BOCA MEADOWS RESTORATION REQUEST FOR BIDS 2021 AMENDMENT 2

This amendment serves to provide additional details on the construction schedule, bid format, and construction activities.

Attachment 1. Revised East Arm Site Plan

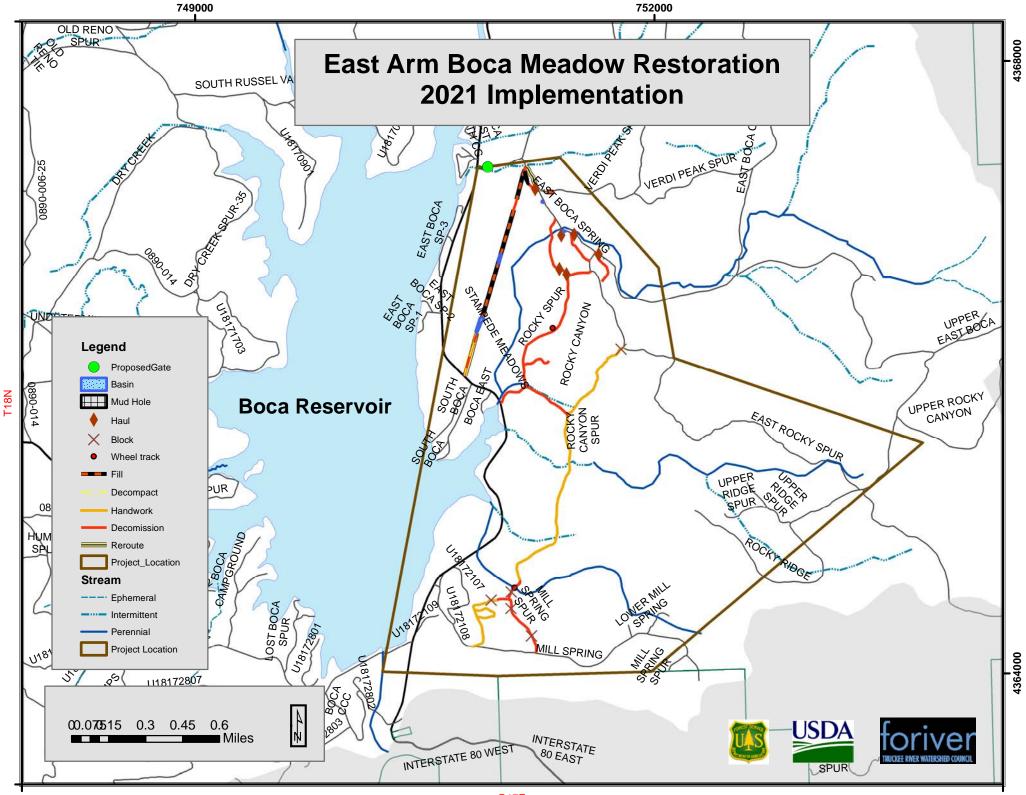
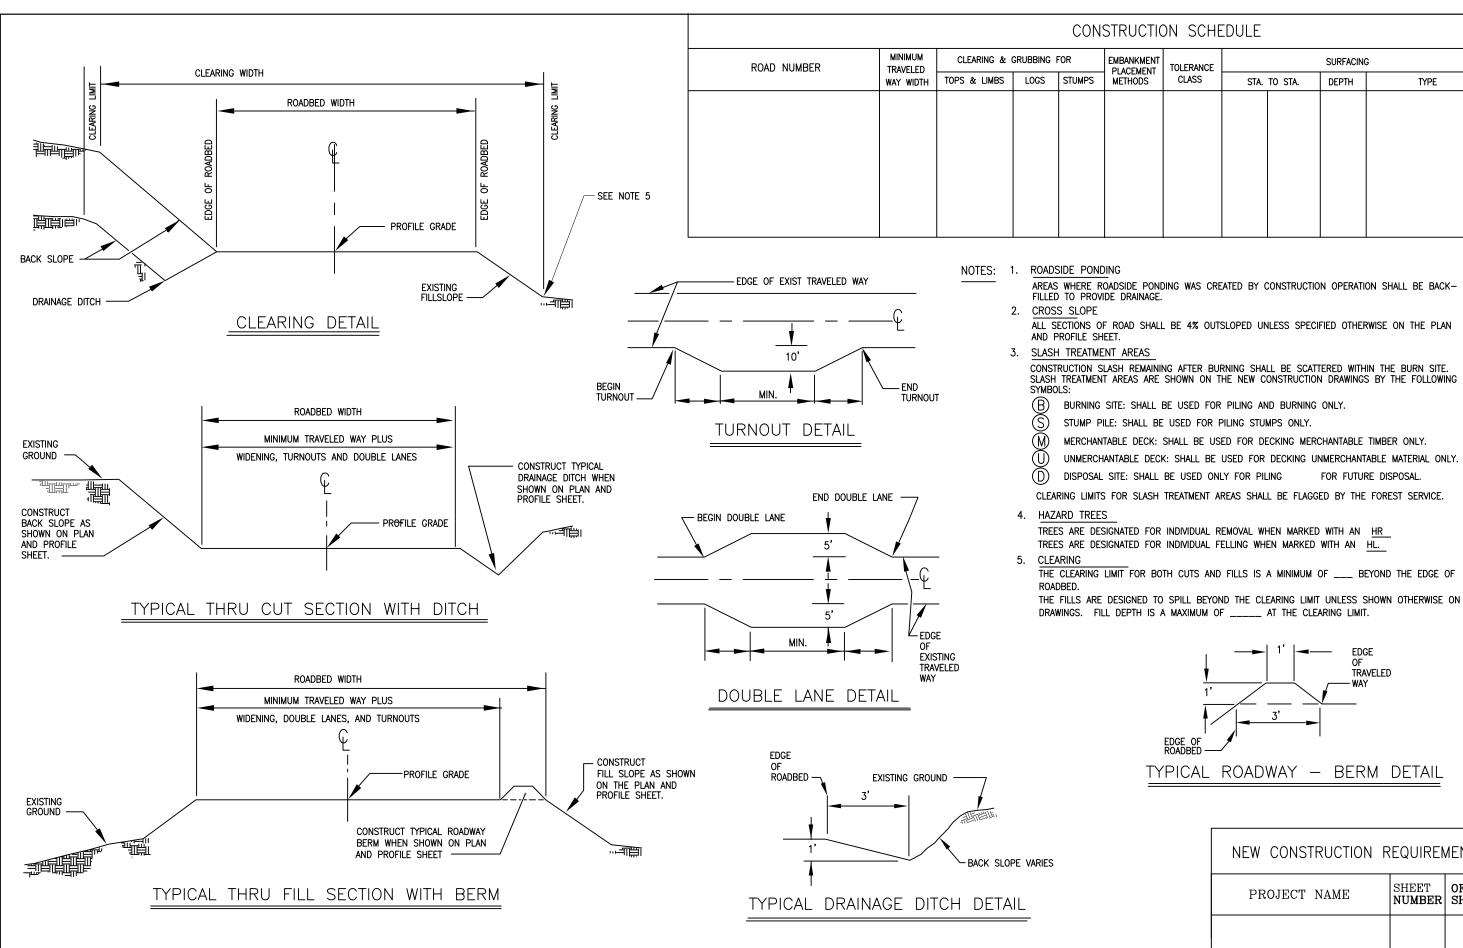
Road decommissioning: 4.7 miles of road will be decommissioned. Some decommissioning will be done by hand or with small equipment, as indicated on the updated site map.

Road re-route. 600 feet of new road will be constructed around the "mud hole" area. The new road will comply with Forest Service specifications (attached). The new segment will include four drivable dips or water bars. Location of the dips or bars will be flagged in the field during construction after the road prism is roughed in. A few larger trees will be removed during the road re-route. These will be used to help block the decommissioned road adjacent to the re-route.

Material import. Approximately 750 cubic yards of material generated from Stampede Meadow will be imported to the "mud hole" area. Approximately 300 cubic yards will be imported from Stampede Meadow to rebuild the fan area.

Gate installation location is approximate as shown on the map, final location will be marked in the field. No other gates are included in this contract.
